RE: Stoney Acres Subdivision – Review of Drainage System

Bay County, MI

STONEY ACRES SUBDIVISION - REVIEW OF DRAINGE SYSTEM

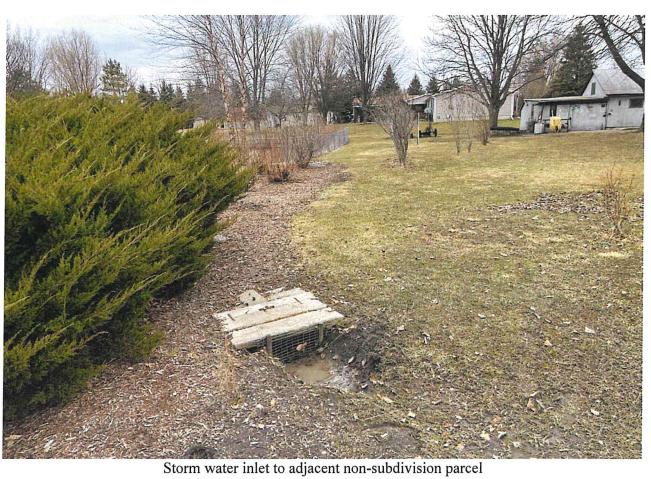
Fallen trees and damaged fence on north side of pond

The Detention Basin appeared to be functioning properly, in regard to storing stormwater and releasing water to the storm sewer outlet, however there are several condition issues that were observed. Trees have fallen from the adjacent property into the basin. These fallen trees have also damaged the fence surrounding the basin at multiple locations. We recommend removing these trees and repairing the damaged portions of fence.

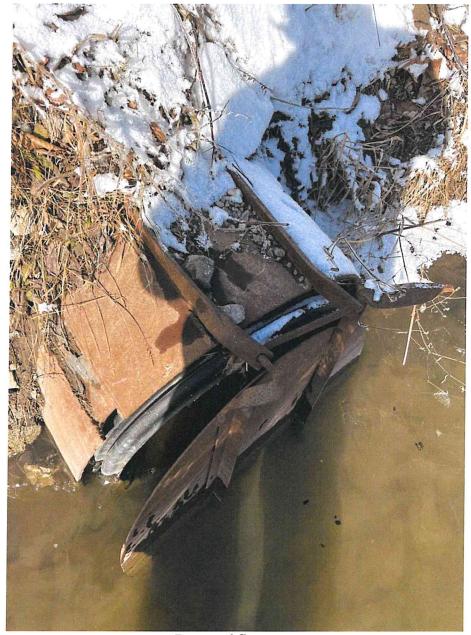
Flap gate unable to close or open due to sediment and damage

On the downstream end of the outlet storm sewer, the flap gate in the county drain is in very poor condition and is not functioning. The flap gate appeared to be a poorly fabricated flap gate by the contractor as opposed to an engineered, commercially available flap gate. The flap gate is very light weight and as a result has sustained severe damage. The bottom of the flap gate was also stuck open due to sediment in the drain bottom. If the sediment were removed, it is unclear if the flap gate would be able to operate correctly due to severe damage and low-quality construction. We recommend replacing the existing flap gate with a heavy duty commercially available flap gate mounted to a pre-cast concrete headwall.
